Re: **Cuatro**
1319 4th St., NW
Traffic Circulation Layout
Engineer's/Architect's Stamp **5-26-16** (J14-D173)

Based upon the information provided in your submittal received 5-26-16, the above referenced plan cannot be approved for Building Permit until the following comments are addressed:

TRAFFIC CIRCULATION LAYOUT PLAN

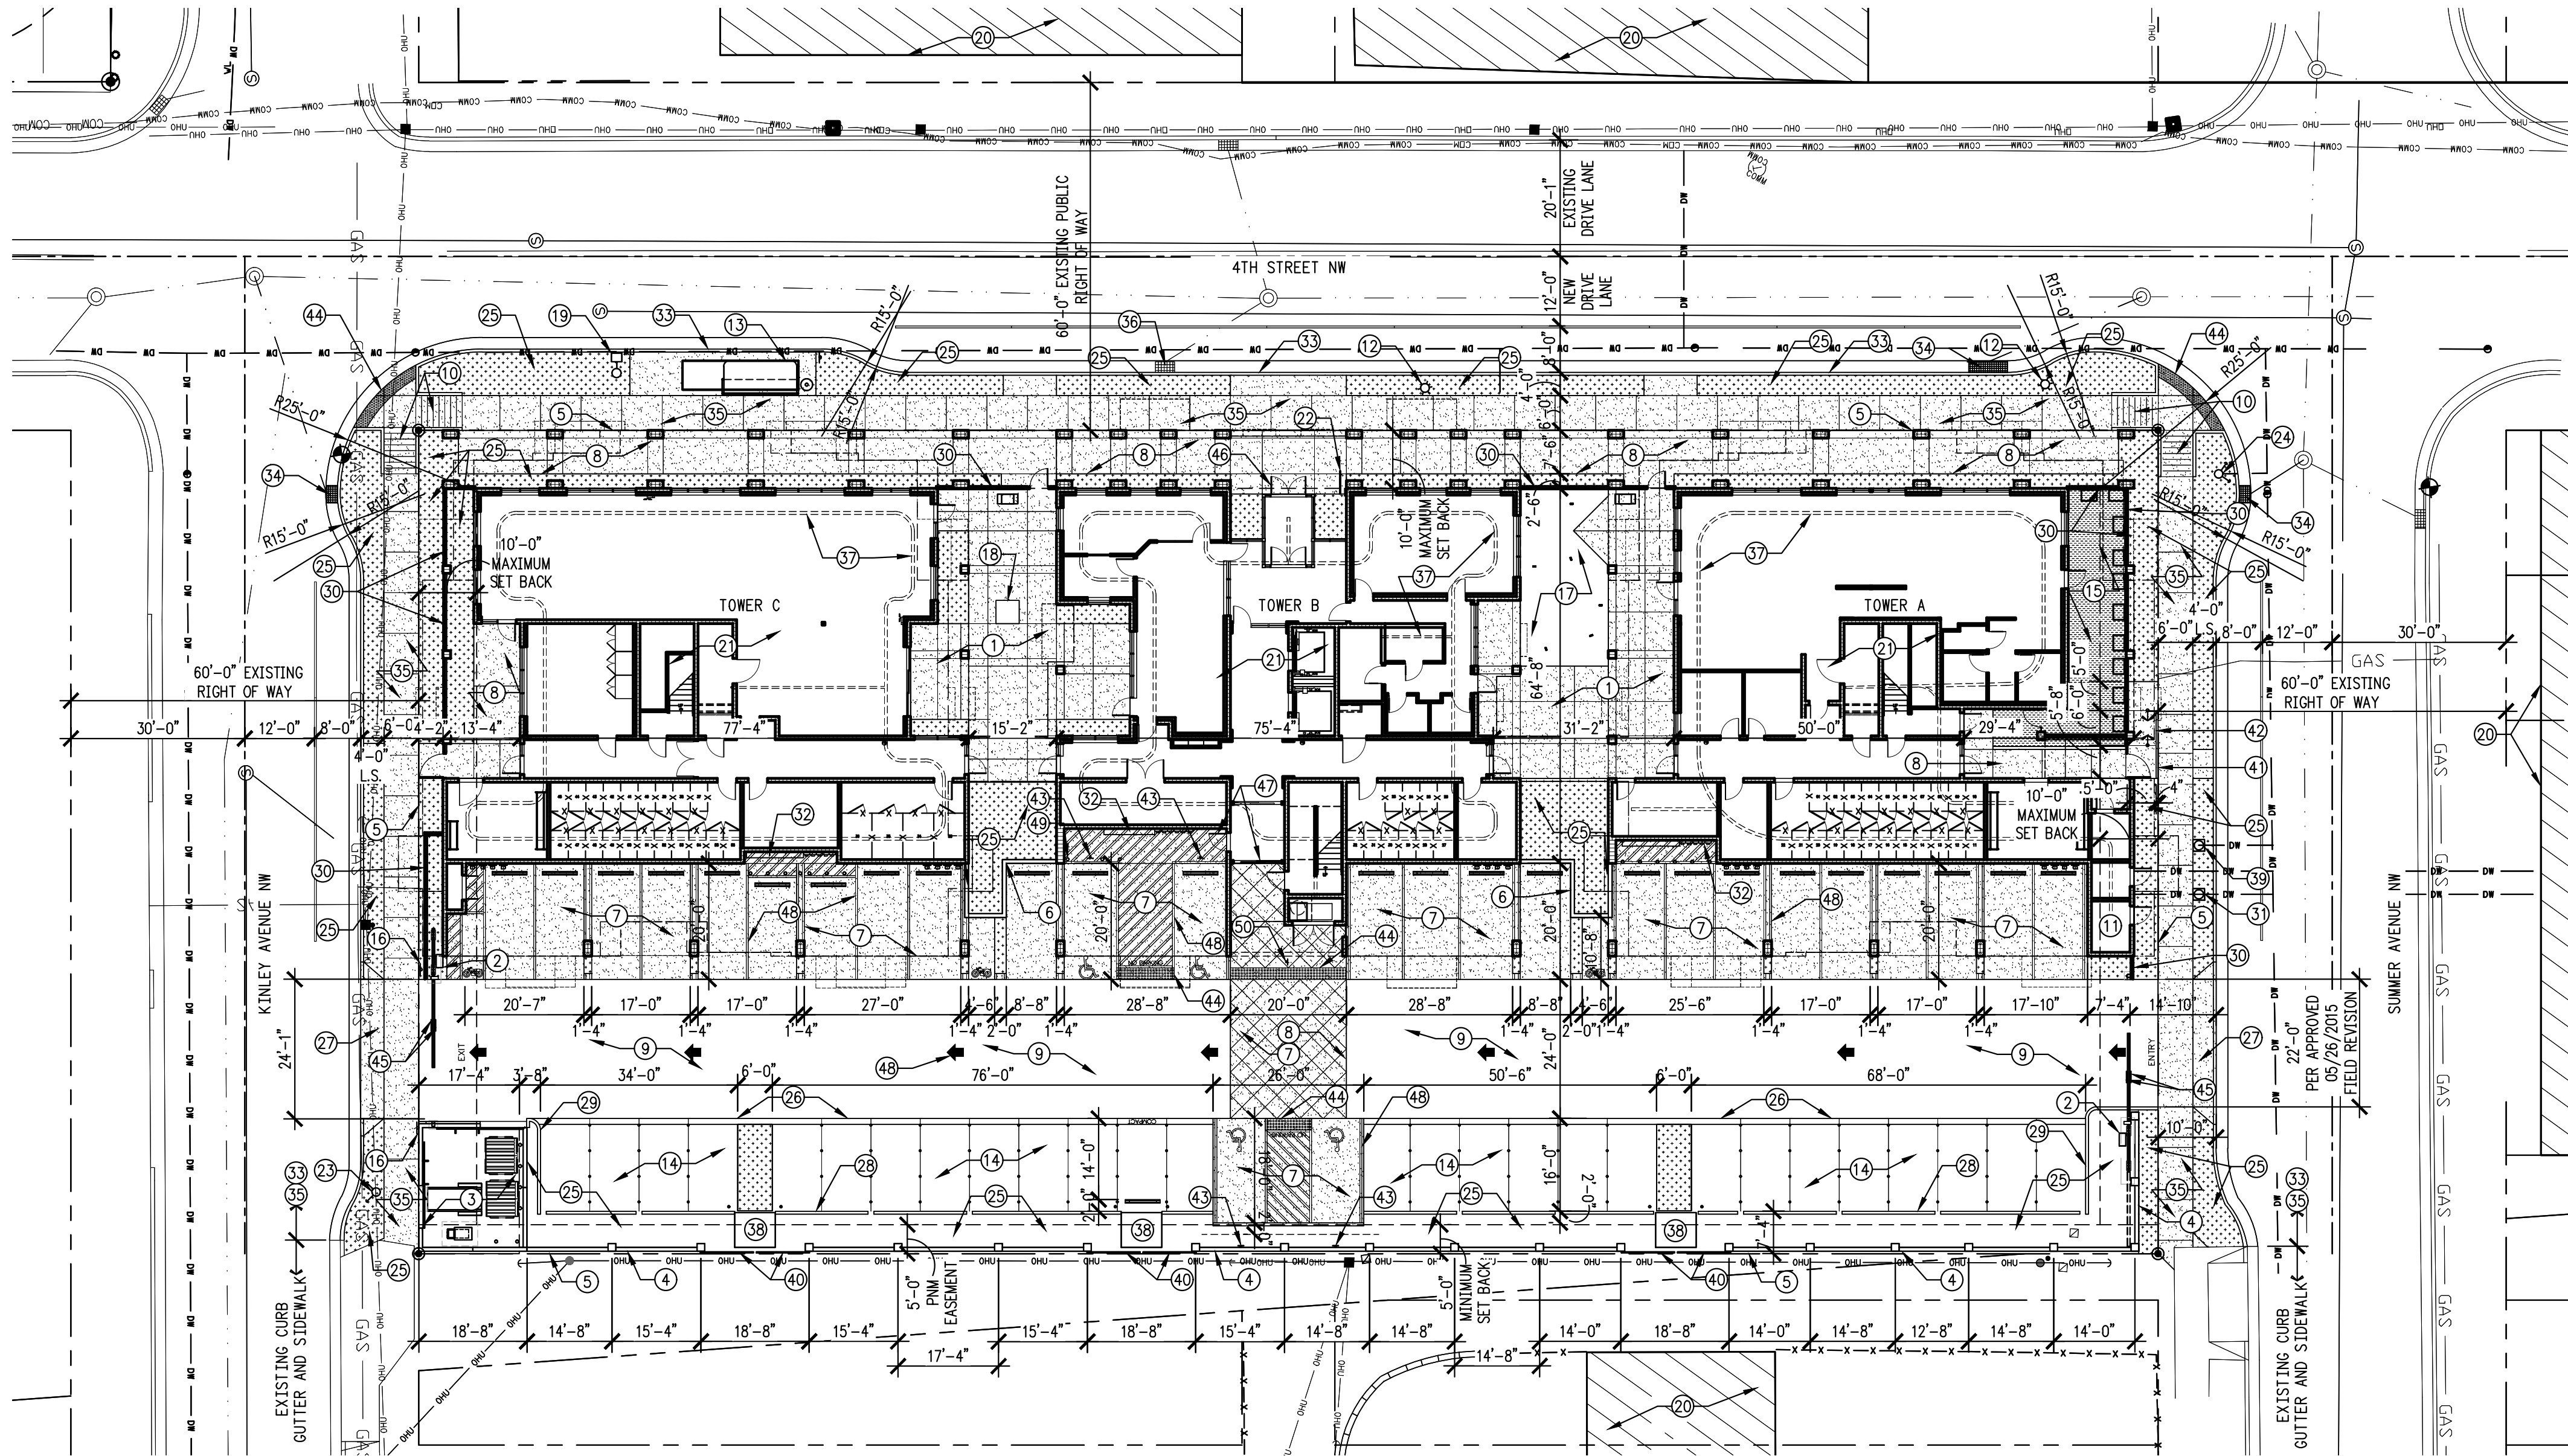
1. Label the compact parking spaces by placing the words "**COMPACT**" on the pavement of each space.
2. The ADA accessible parking sign must have the required language per 66-7-352.4C NMSA 1978 "**Violators Are Subject to a Fine and/or Towing.**" Please call out detail and location of HC signs.

3. Show all drive aisle widths and radii.
4. List radii for all curves shown; for passenger vehicles, the minimum end island radius is 15 ft. Landscape island radius for delivery trucks, fire trucks, etc. is 25 ft. or larger.

5. Please provide a sight distance exhibit (see the *Development Process Manual, Chapter 23, Section 3*). Please show this detail for Kinley Ave. and Summer Ave.

6. Please add the following note to the clear sight triangle: "Landscaping and signage will not interfere with clear sight requirements. Therefore, signs, walls, trees, and shrubbery between 3 and 8 feet tall (as measured from the gutter pan) will not be acceptable in this area."

7. Please add a note on the plan stating "All improvements located in the Right of Way must be included on the work order."
8. Unused curb cuts must be replaced with sidewalk and curb & gutter. A build note must be provided referring to the appropriate City Standard drawing.

9. All broken or cracked sidewalk must be replaced with sidewalk and curb & gutter. A build note must be provided referring to the appropriate City Standard drawing.
